ECR for “Space reservation for the BBLR wire”

52nd HL-LHC Technical Coordination Committee (TCC) meeting , 21st June 2018

LHC-LJ-EC-00XX

Space Reservation Modifications to the IR1 and IR5 of the LHC for Beam-Beam Long-Range Compensators

half-cell 5R1

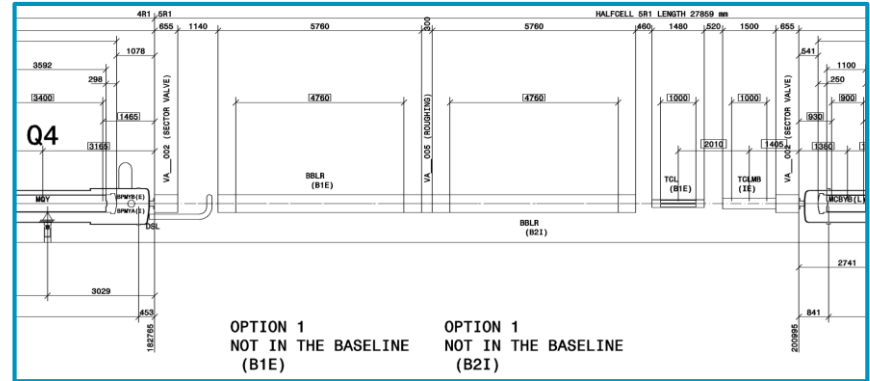
Replace reservation in half-cell 4L1/5 and 4R1/5 with half-cell 5L1/5 and 5R1/5

Update drawings LHCLSXH_0001 and 0002, 0009 and 0010

Space reservation for BBLR racks

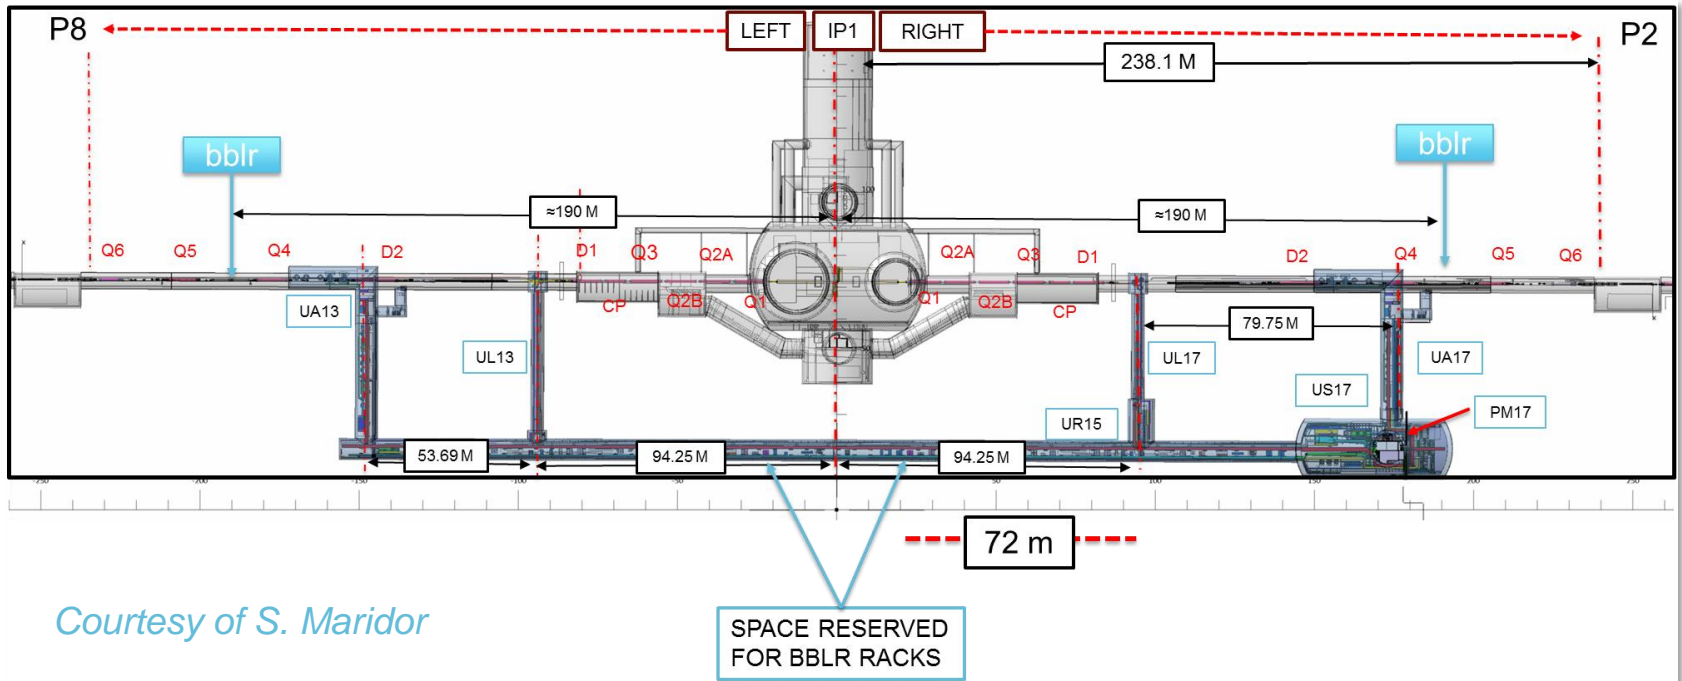
Note: 4 power converters recovered from BBCW tests, sufficient if 2 wires per side powered in series.
